UNITED STATES PATENT AND TRADEMARK OFFICE

APPLICATION NO.	FILING DATE	FIRST NAMED INVENTOR	ATTORNEY DOCKET NO.	CONFIRMATION NO.
10/680,560	10/06/2003	Tuoc Tan Nguyen	816020-100044-US	4130
34026	7590	10/05/2005	EXAMINER	
JONES DAY 555 SOUTH FLOWER STREET FIFTIETH FLOOR LOS ANGELES, CA 90071			MILLER, CHERYL L	
			ART UNIT	PAPER NUMBER

Office Action Summary	Application No. 10/680,560	Applicant(s) NGUYEN ET AL.	
	Examiner Cheryl Miller	Art Unit 3738

US 6,425,916 B1

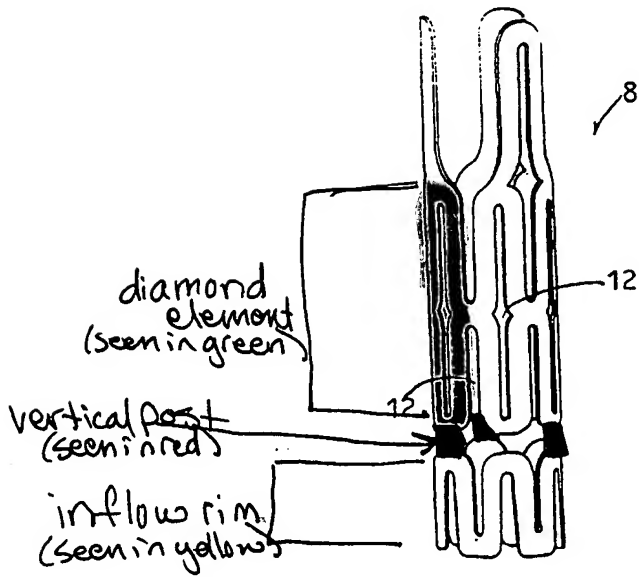
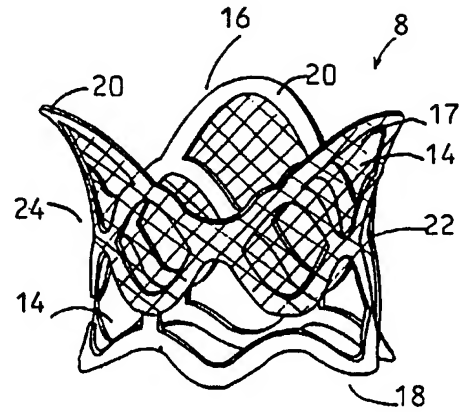
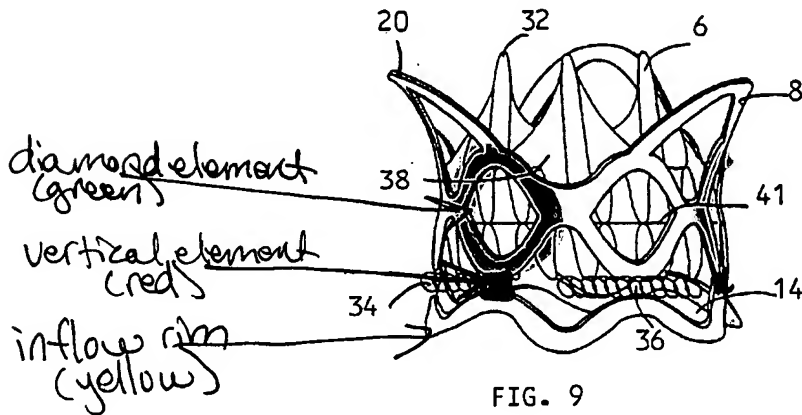
Claims 1, 3, 4, 6, and 7 are rejected under 35 U.S.C. 103(a) as being unpatentable over Garrison et al. (US 6,425,916 B1, cited in IDS) in view of Myers et al. (US 2002/0052651 A1, cited previously). Referring to claim 1, Garrison discloses a valve assembly (see fig.5, 6, 9) comprising a replacement valve (6 or 38, seen in fig.10) having an inflow annulus (41; bottom of fig.), an outflow annulus (top of fig), and a plurality of leaflets (39) in between the inflow and

outflow annulus (fig.10, 11), and an expandable and collapsible anchoring structure (8; fig.7-9) dimensioned to extend longitudinally from an inflow attachment location to an outflow attachment location, the anchoring structure (8) comprising a singled flared inflow rim (18; there is only one inflow rim) and only three flexible vertical posts (posts extending from 18, seen in fig.7-9, particularly in fig.7; only three are shown) extending from the inflow rim (18) in a direction toward the outflow annulus of the valve (6) wherein the vertical posts further comprise a single diamond shaped (opening 14; there only being *one* opening 14 associated with each vertical post, see attachment 1) element having no direct contact with the replacement valve (there is no contact, since the anchoring structure 8 is flared away from the valve 6, and the valve is only in contact at protrusions 36, which extend through openings 14, below the diamonds). Garrison however, discloses the inflow and outflow annulus to be straight rather than scalloped. Myers teaches in the same field of valve assemblies, the use of scalloped inflow and outflow annuluses on replacement valves like the one of Garrison (see figures 8, 9, 17, 28, and 29), as an improvement to straight annuluses, in order to provide increased hemodynamic performance, minimized creasing, and an overall better fit within the native valve [0088-0090]. It would have been obvious to one having ordinary skill in the art at the time the invention was made to combine Garrisons heart valve prosthesis, with Myers teaching of scalloping annuluses of valve prostheses, in order to provide increased hemodynamic performance, minimized creasing, and an overall better fit within the native valve.

FIG. 21

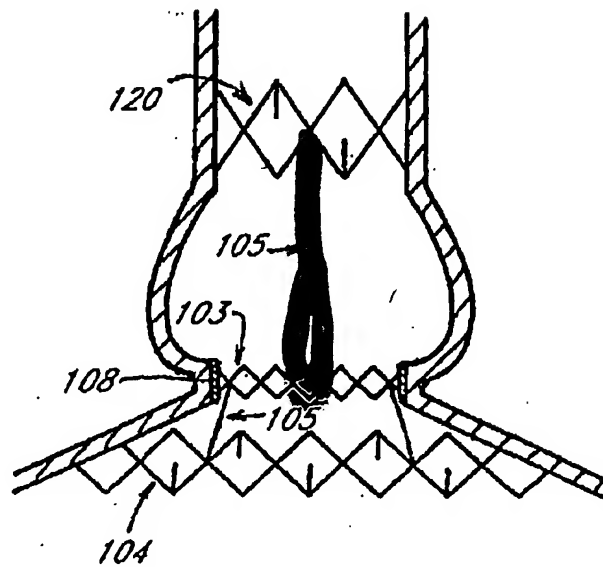
Claims 1, 3, 4, 6, and 7 are rejected under 35 U.S.C. 103(a) as being unpatentable over Seguin et al. (US 2004/0093060 A1, cited previously) in view of Myers et al. (US 2002/0052651 A1, cited previously). Referring to claim 1, Seguin discloses a valve assembly (see fig.19, 21, and 22) comprising a replacement valve (10 or 102; see fig.4, 14, and 17) having an inflow annulus, an outflow annulus, and a plurality of leaflets in between the inflow and outflow annulus (fig.4, 14, 17 and respective portions of the specification), and an expandable and collapsible anchoring structure (stent in fig.19, 21, and 22) dimensioned to extend longitudinally from an inflow attachment location to an outflow attachment location, the anchoring structure comprising a singled flared inflow rim (104+105 in figs) and only three flexible vertical posts (105a+105b+103; see attachment 2) extending from the inflow rim (104+105) in a direction toward the outflow annulus of the valve wherein the vertical posts (105a+105b+103) further comprise a single diamond shaped (portion of 103 coinciding with 105) element having no direct contact with the replacement valve (diamond is located below where the valve is placed, therefore, no contact). Seguin however, discloses the inflow and outflow annulus to be straight rather than scalloped. Myers teaches in the same field of valve assemblies, the use of scalloped inflow and outflow annuluses on replacement valves like the one of Seguin's (see figures 8, 9, 17, 28, and 29), as an improvement to straight annuluses, in order to provide increased hemodynamic performance, minimized creasing, and an overall better fit within the native valve [0088-0090]. It would have been obvious to one having ordinary skill in the art at the time the invention was made to combine Seguin's heart valve prosthesis, with Myers teaching of scalloping annuluses of valve prostheses, in order to provide increased hemodynamic performance, minimized creasing, and an overall better fit within the native valve.

Referring to claims 3, 4, 6, and 7, see figures 19, 21, and 22, and respective portions of the specification.
